July 21, 1964

LINEAR PHASOLVER MEASURING ENGINE

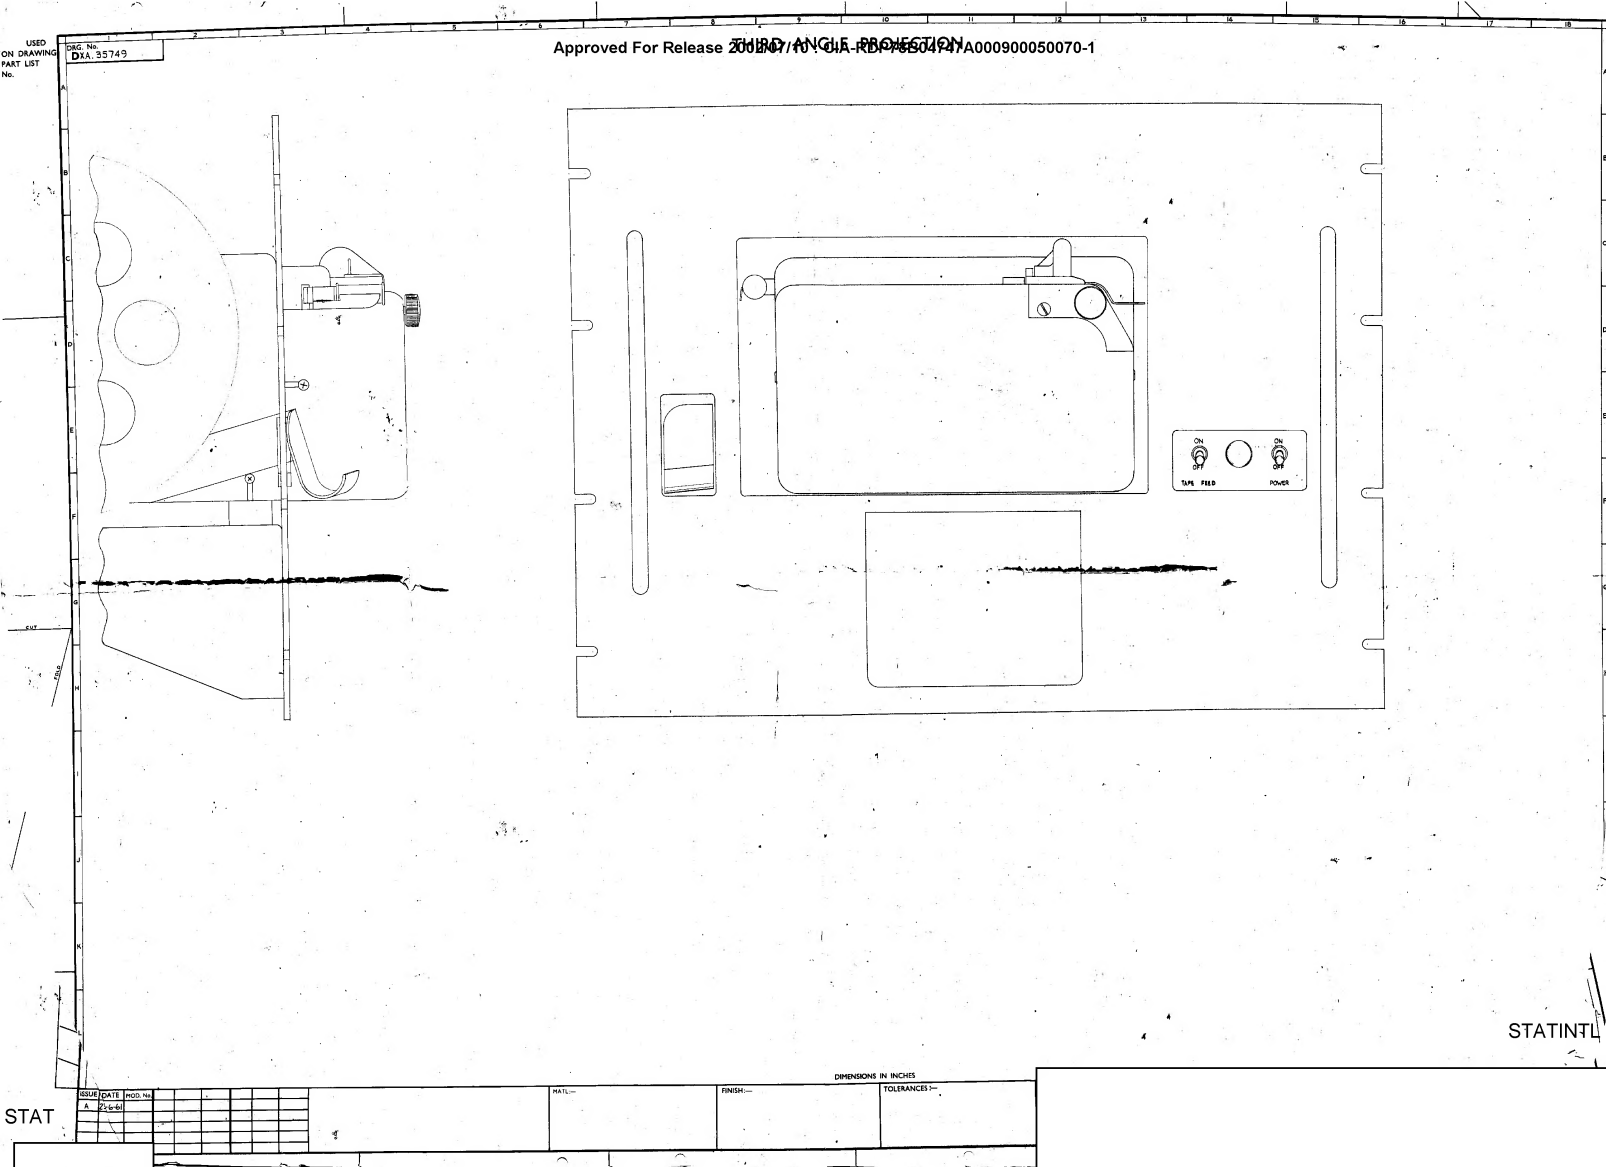
Copy of Dataphone options used.

Which points are input & output lines  
connected to.
